**Site Visit Observations of Team consisting for Assi River Rejuvenation by Pond
Conservation in the Catchment Area of Assi River**

Date of Visits: 23/08/22-26/08/22.

Background and purpose of the visit

Origin Pond of Assi River:

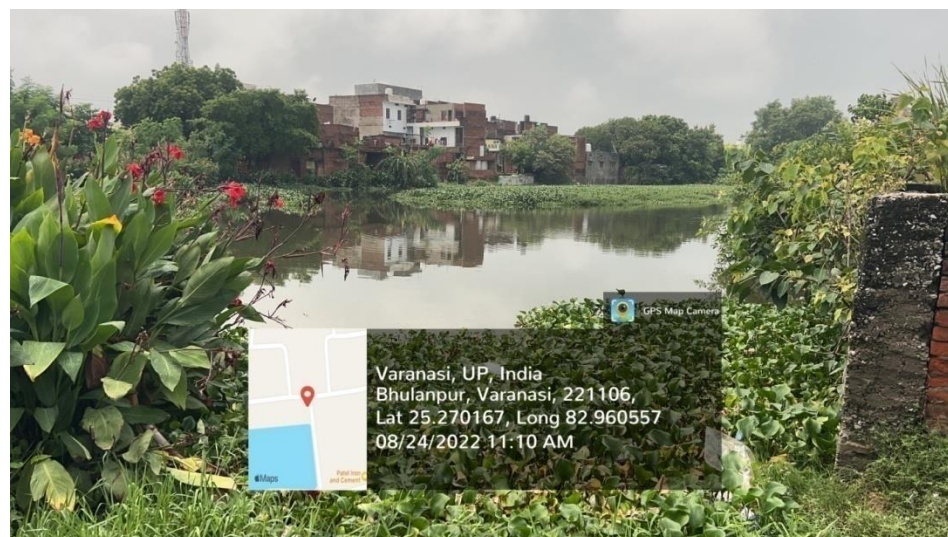
1. Pond is heavily encroached; no boundary is marked and used for fish farming allotted by local Pradhan.
2. Due to absence of Sewage network all household waste water & sewerage directly or indirectly enters into the pond.
3. Solid waste dumping was observed.

PushkarTalab:

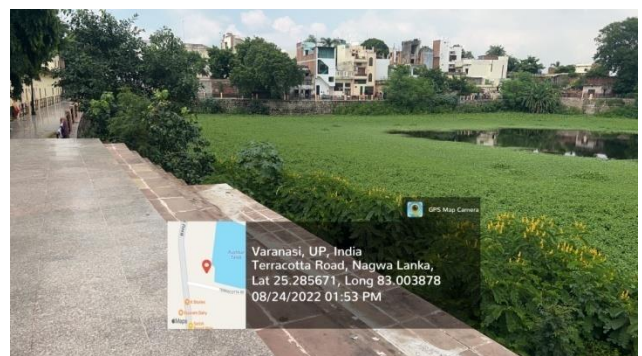
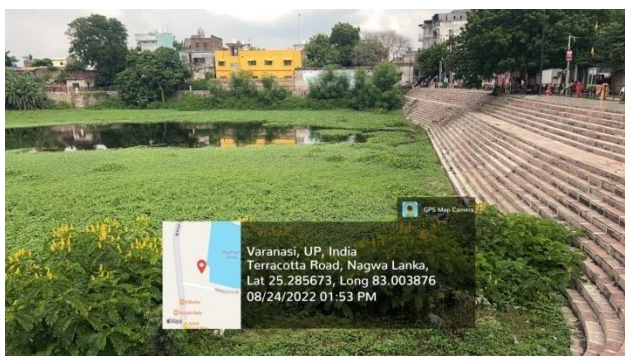
PushkarTalab is already rejuvenated by VDA funded by NMCG. According to local people pond water depth is around 40 to 45 feet and having good aqua culture like big fishes, turtles etc. At the time of rejuvenation, ponds inlet and outlet have blocked due to construction activities like bank steps & ghat development, due to this water is coming in the pond through seepage under the stairs from nearby Assi River/ Ganga River.

Lahartara Pond

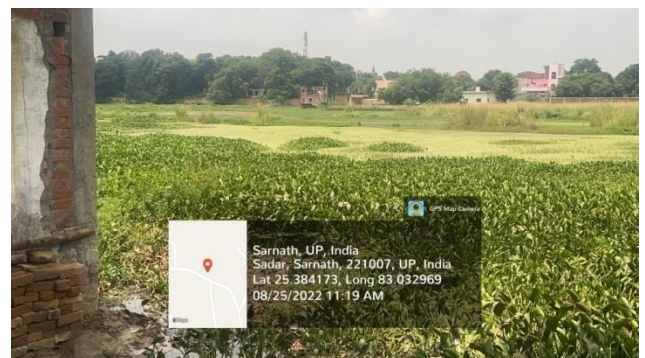
No Eicchornia was found. Some work of Natural Treament was taken up by VDA however later it was stopped due to dispute between ASI and VDA. The treatment showed some sludge digestion has taken place as the level of water body has reduced. The pond was clean as compared to adjacent one.

NarokharTalab near WTP, Sarnath, Varanasi

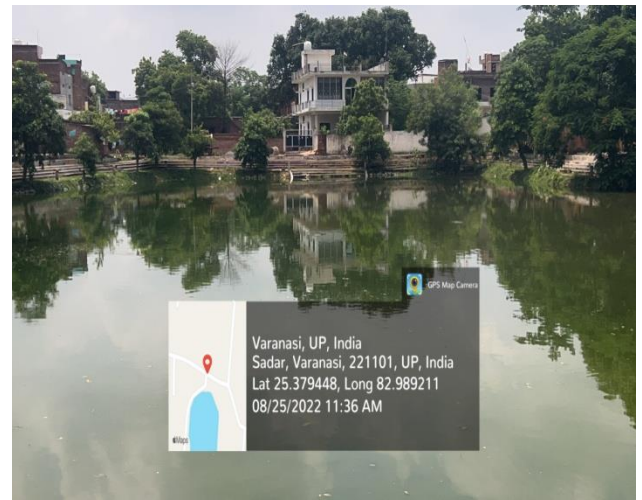
NarokharTalab is situated back side of WTP near Sarnath Railway Station and expanded in the area of 85 acres. Pond is completely filled with Eicchornia&water chest nuts are also grown by locals.

Assi River/ Nala Encroachment Areas:

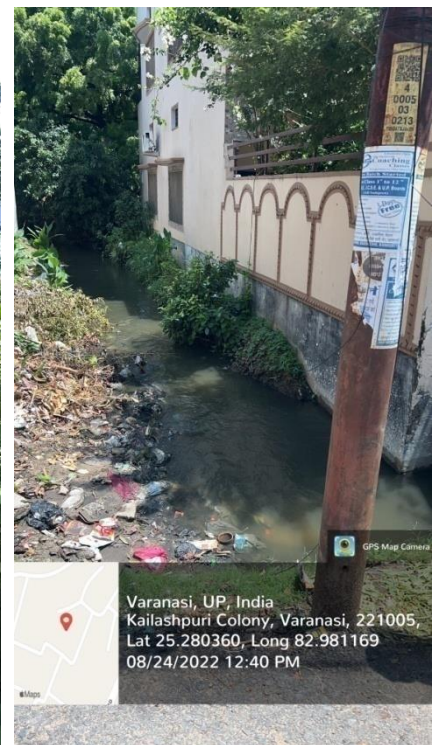
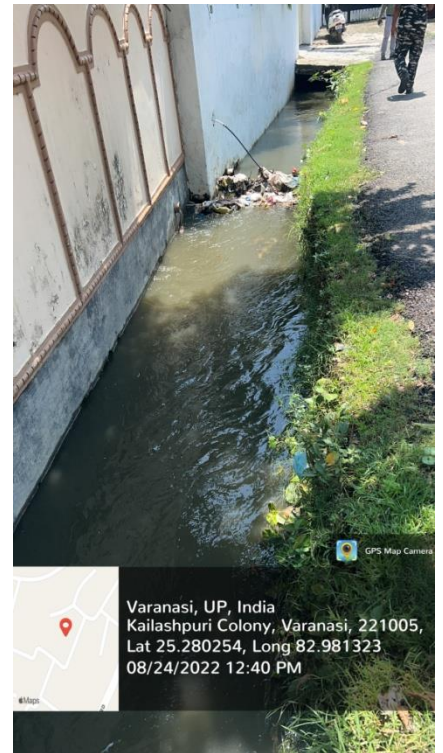
2. Solid waste dumping into Assi River/ Pond/ Kunds directly.
3. Heavy encroachment at River Embankments/ waterbodies.
4. Unprecedented residential commercial growth due to VIP constituency.

- i. The encroachment removal at Assi/ Ponds/ Kunds at Varanasi is required. Identification and marking of pond boundary with old revenue records needs to be done to restrict future encroachment.
- ii. No possibility to remove huge encroachment along Assi river channel - nearly 1000 homes, therefore the restoration plan should primarily focus towards increasing the
